SERVICE INFORMATION BULLETIN

APPLICABILITY: 2020-22MY Legacy & Outback

NUMBER: 15-296-22

SUBJECT: Denso CP1 MID & HIGH (11.6" Display Screen)
Unintentional Finger-Touch Operations

11.6" Center Information Display (CID)

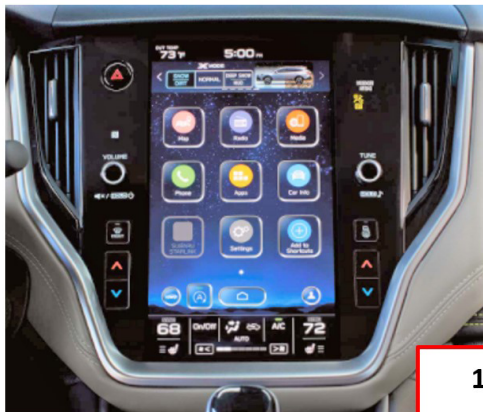
This Service Information Bulletin addresses the rare cases of “ghost touch” (activation of touch screen buttons as though touched by finger(s)). The 11.6” CP1 MID & HIGH Model Center Information Display (CID) touchscreen may appear to detect input without any actual contact (finger or other) with the touchscreen. If this symptom is experienced, the CID will require replacement. Software reprogramming will not remedy this issue. The NEW CIDs contain advanced logic that provides a more precise finger detection operation.

Part Description	Part Number
Display Assembly	86213AN65C
	86213AN66C
